**Subject: MHI's Response to US-APWR DCD RAI No. 633-4857 Revision 0**

Response to Request for Additional Information No. 633-4857  
Revision 0

**RAI NO.:** NO. 633-4857 REVISION 0  
**SRP SECTION:** 09.01.04 – LIGHT LOAD HANDLING SYSTEM (RELATED TO REFUELING)  
**APPLICATION SECTION:** 09.01.04  
**DATE OF RAI ISSUE:** 09/17/2010

**QUESTION NO.: 09.01.04- 21 Follow Up to RAI 09.01.04-16**

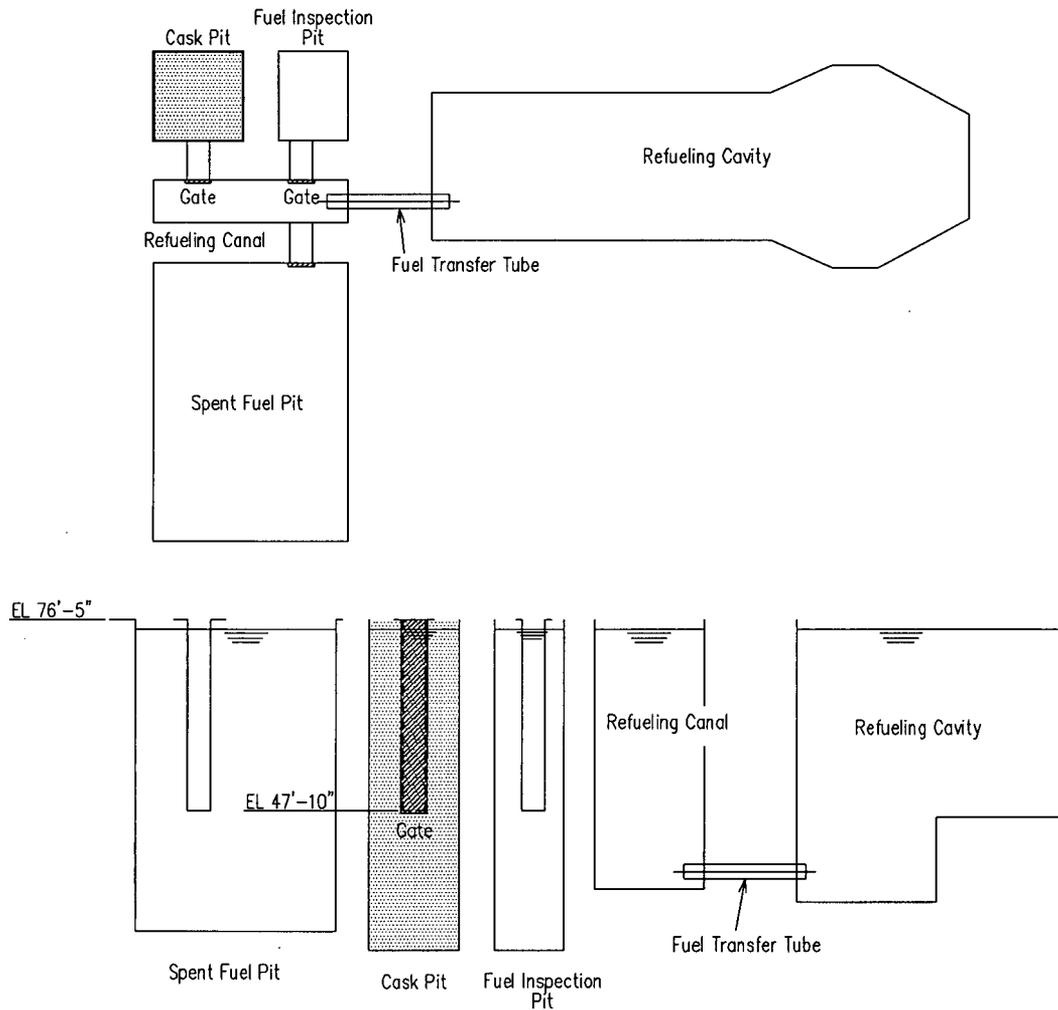
1. The response indicated that the permanent cavity seal (PCS) is a stainless structure that is permanently attached to both the reactor vessel flange and the refueling cavity floor with both bolted joints and welds. The response included a figure to show the PCS, but it did not indicate where the welds are located or how the bolted joints are sealed to prevent leakage. The DCD also needs to explain/specify:
  - a. if the seal is treated as a structure or mechanical component,
  - b. codes or standards that apply to the seal assembly,
  - c. codes/standards that apply to welds, and distinction between shop vs. field welds, and
  - d. why catastrophic failure of welds will not occur.

Additional information regarding the permanent cavity seal is provided as follows:

- a) The PCS is treated as a mechanical component.
- b) Material selection and seal manufacture are performed in accordance with the appropriate ASME criteria or criteria recommended by the manufacturers.

- c) Welding is performed in accordance with appropriate ASME criteria. Segments of the PCS are assembled by welding the fixed parts and segments of the seal plates on both ends. The segments are shaped into a ring by welding one another at the shop or on-site depending on transportation conditions for a specific site. The ring of the PCS is fixed on the reactor vessel flange and refueling cavity floor with bolts, and seal welding is performed around the PCS and the bolts to ensure on-site seal performance.

- d) The integrity of the PCS is confirmed through evaluation in terms of fatigue caused by thermal stress over the life of the plant, and strength against water pressure during refueling operation. Since the PCS is protected by the lid against an accidental fuel drop, catastrophic failure of the welds will not occur.

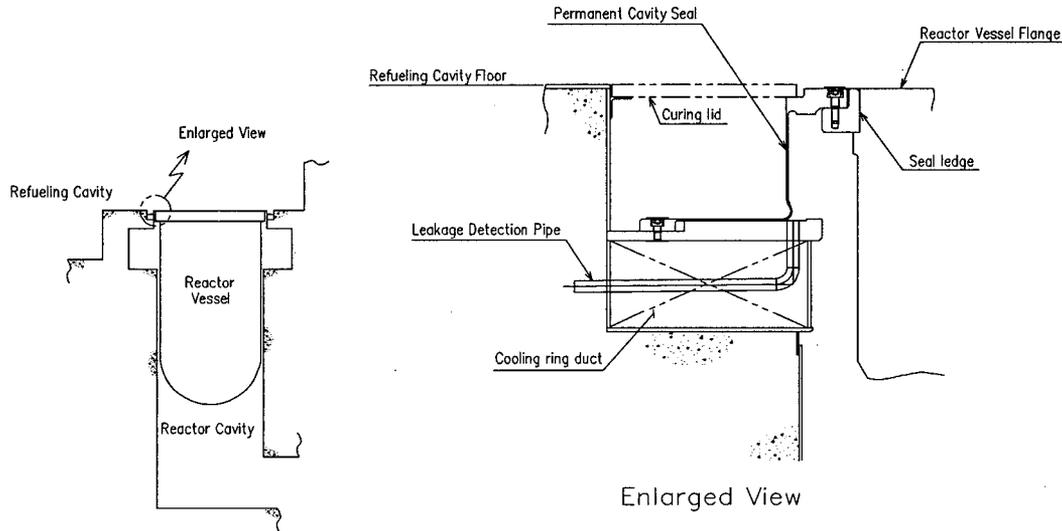
seals on the cask pit and fuel inspection pit gates will cause the refueling pit to drain down (i.e. diagrams showing relative elevations and flow paths need to be provided).

Regarding the leakage through the seal on the cask pit and the fuel inspection pit gates, the relative elevation of the bottom of the pit gate, refueling cavity, and other structures are shown in the figure below. The cask pit has no water during refueling operation and is isolated from the refueling canal with a gate. If unexpected leakage from the gate occurs, the water flows from the refueling cavity, refueling canal and spent fuel pit into the cask pit through the gate.
